ADDENDUM NO. 3

RICHLAND CREEK DAM AND RESERVOIR

PAULDING COUNTY BOARD OF COMMISSIONERS
DALLAS, GEORGIA

RESPONSES TO QUESTIONS RECEIVED FROM MAY 21, 2016 THROUGH JUNE 20, 2016

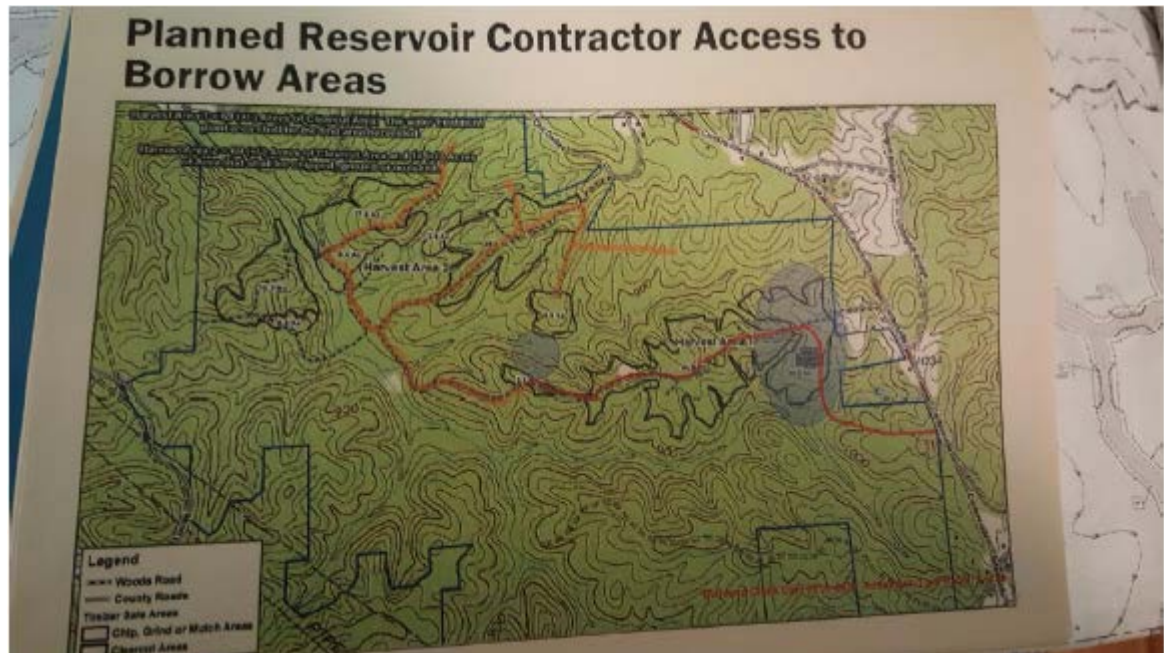
- c. Please clarify the intent of the Crossings 3a, 3b and 4 as shown on Sheet 4-ESC13 (revised 5/23/2016) which are not consistent with access routes shown in “ORANGE” below. Why are Crossings 3a, 3b and 4 there? Additionally, Crossing 2 on Sheet 4-ESC13 (revised 5/23/2016) is designated as Sr-B suggesting a Bridge crossing as opposed to Sr-C at other locations. The table provided in Addendum #1 suggests all culverts; is there any expectation or requirement that Dam Contractor must construct a temporary bridge crossing at this location? It may be needed?

Answer: Crossings are there to facilitate future reservoir clearing and are not in contract. No, there is not an expectation of a temporary bridge crossing at this location. Crossings are there to facilitate future reservoir clearing and are not in contract.
